Office Action Summary	Application No. 10/593,642	Applicant(s) GUTMAN ET AL.	
	Examiner MARJORIE CHRISTIAN	Art Unit 1797

1. This is the initial Office action based on the application filed September 21st, 2006.
2. **Claims 1-27** are pending, **claims 1-17** have been fully considered and **claims 18-27** have been withdrawn from consideration.

Group I, **claims 1-17**, drawn to a fluid treatment element with a fluid treatment pack, pleat and spacer arrangement.

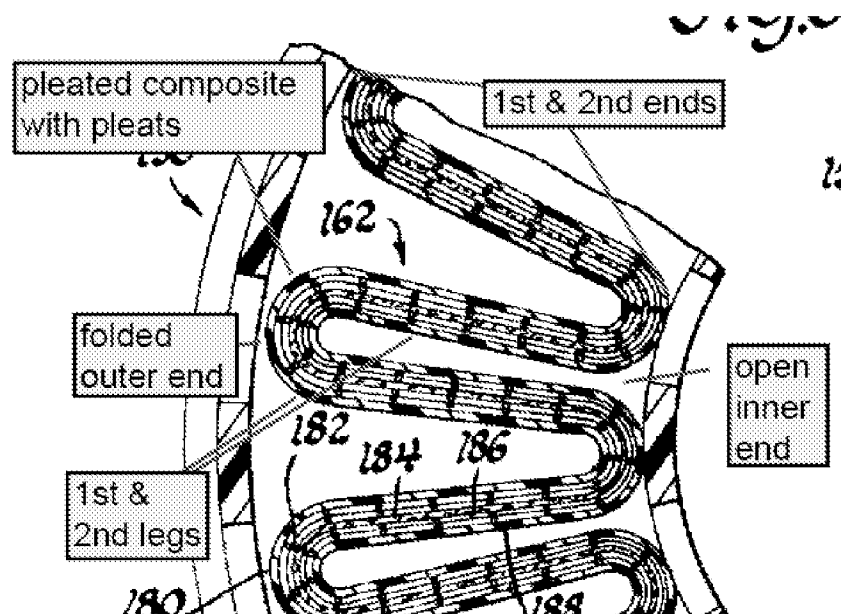
As to **claims 1-6, 8-12**, HAUK discloses a fluid treatment element (Fig. 8-9) comprising:

- a hollow, generally cylindrical fluid treatment pack and pleated composite (162);
- the pleated composite (162) includes a fluid treatment medium (184) and drainage medium (182) positioned along the outer surface of the fluid treatment medium, wherein the medium (182) can be considered a drainage medium because it has the typical characteristics of a drainage medium including parallel strands (Fig. 7, Ref. 182) transversely overlaid with other parallel strands;

- a spacer arrangement (186) associated with the pleats of the fluid treatment pack (162) inwardly from the inner surface of the fluid treatment medium (184), wherein the spacer arrangement (186) includes a spacer (186) positioned proximate the first and second ends of the fluid treatment and defines a region which extends along each pleat between the spacer (186) which is substantially free of structure (C9/L21-29, C10/L35-44); the spacer arrangement (186) is positioned proximate to the fluid medium and wall (188) that defines the thin flow channel [*region free of structure, first flow path*] (**Claims 5,12**); a second fluid flow path extends through the pleated fluid treatment medium from or to the first fluid flow path (C9/L21-29); and the spacer and region free of structure are positioned between the legs (**Claims 2,9**).

- HAUK does not appear to disclose a second porous medium (second spacer) and an additional porous medium (drainage medium of **Claims 3-4,10-11**), wherein the spacer arrangement is between the fluid medium and additional porous medium, however, it would be obvious to a person having ordinary skill in the art to include multiple layers of drainage medium (182) [*second spacer and drainage medium*], as it has been held that mere duplication of parts has no patentable significance *In re Harza*, 274 F.2d 669, 124 USPQ 378 (CCPA 1960). Further, providing multiple layers of porous medium in a pleated filter media is well known as evidenced by COOK. COOK discloses multiple layers of porous media as shown in Fig. 12. Therefore, the invention as a whole would have been

- a core arrangement (174/167) positioned in the hollow interior of the fluid treatment pack (162) and a blind portion (167) axially spaced from the first end and the second end of the fluid treatment pack (162), wherein the blind portion (167), made of glue/cement (i.e. urethane C9/L57), resists fluid flow radially inwardly from the axially extending regions of the fluid treatment pack (162, see particularly Fig. 6, 9, C9/L55-60); and
- first and second end caps (156/160) sealed to the first and second ends of the fluid treatment pack (162) (**Claim 6**), each end cap having a central opening (158/161) which fluidly communicates with the axially extending regions of the pleats (C10/L45-51).

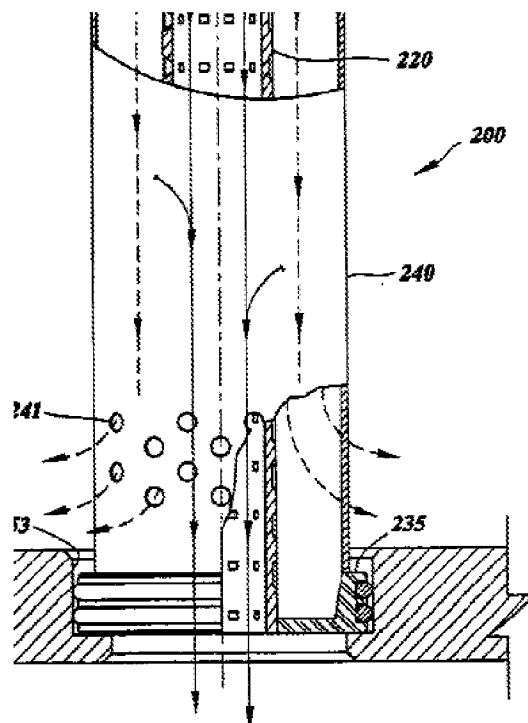
As to **Claims 1-6, 13-17**, HAUK discloses a fluid treatment element (Fig. 4-5) comprising:

- generally cylindrical fluid treatment pack and pleated composite (62, see also annotated figure above), and
- the pleated composite includes a fluid treatment medium (84) having an inner and outer surface and a drainage medium (86) positioned along the inner surface of the fluid treatment medium;

- a spacer arrangement (80/82) extending between the first and second legs (**Claim 14**), packed outwardly from the outer surface of the fluid treatment medium (84), the spacer arrangement includes first (80) and second (82) spacers positioned proximate the first and second ends of the fluid treatment pack, and a region substantially free of structure which extends along each pleat between the spacer (80/82) and fluid treatment medium (84) (**Claim 17**) (C7/L48-50); and the spacer and region free of structure are positioned between the legs (**Claims 2**) proximate to the fluid treatment medium (84) (**Claim 5**). The spacer arrangement defines a first flow path (C7/L48-50) and the composite includes a second fluid flow path which extends through the pleated fluid treatment medium from the first fluid flow path (C7/L54-59). The spacer (82) can be considered a drainage medium because it has the typical characteristics of a drainage medium including parallel strands (Fig. 3, Ref. 82) transversely overlaid with other parallel strands (**Claims 4, 16**).

- HAUK does not appear to expressly disclose an additional porous medium (drainage medium of **Claims 3-4, 15-16**), wherein the spacer arrangement is between the fluid medium and additional porous medium, however, it would be obvious to a person having ordinary skill in the art to include multiple porous medium layers (i.e. 82) [*drainage medium*], as it has been held that mere duplication of parts has no patentable significance. Further, providing multiple layers of porous medium in a pleated filter media is well known as evidenced by COOK. COOK discloses multiple layers of porous media as shown in Fig. 12. Therefore, the invention as a whole would have been *prima facie* obvious to one of ordinary skill in the art at the time the invention was made.

- an outer surround (64/67) positioned around the exterior of the fluid treatment pack, wherein the blind portion spaced from the first and second ends (67) is made of glue/cement (C5/L50-57) that resists fluid flow from the axially extending regions of the fluid treatment pack (C5/L50-57); and

- first and second end caps (16/18) respectively sealed to the first and second ends of the fluid treatment pack (**Claim 6**), each end cap having a central opening (20/24) which fluidly communicates with the interior of the fluid treatment pack (C4/L52-59).
